Access Compliance Report Public Rights-of-Way (RR Crossings)

Intersection ID: 10038386	Main Street: SOUTH_BV	Location: N/A
ADA ID: 08E9B25FB4CA	Overall Compliance: No	Severity Score: 0.0
Codes/Mitigation Info/Possible Solution		Field Measurements/Component Compliance

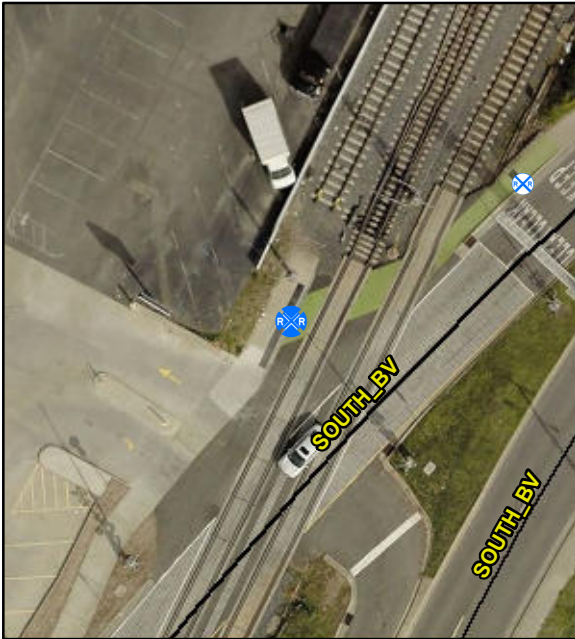
Compliance	Description	Data
Yes	DWS Provided?	Yes
Yes	DWS Contrast?	Yes
Yes	DWS Width (in)	Yes
Yes	DWS Length (in)	24.0
No	DWS Offset (in)	6.0
No	Pedestrian Gate?	No
N/A	DWS Outside Gate?	N/A
N/A	Rail Type?	LightRail
No	Flangeway Gap (in)	3.0
Yes	Sidewalk Width (in)	288

Remove & Replace Detectable Warning System. Provide Pedestrian Gate. Remove & Replace Walking Surface Adjacent to Rail.
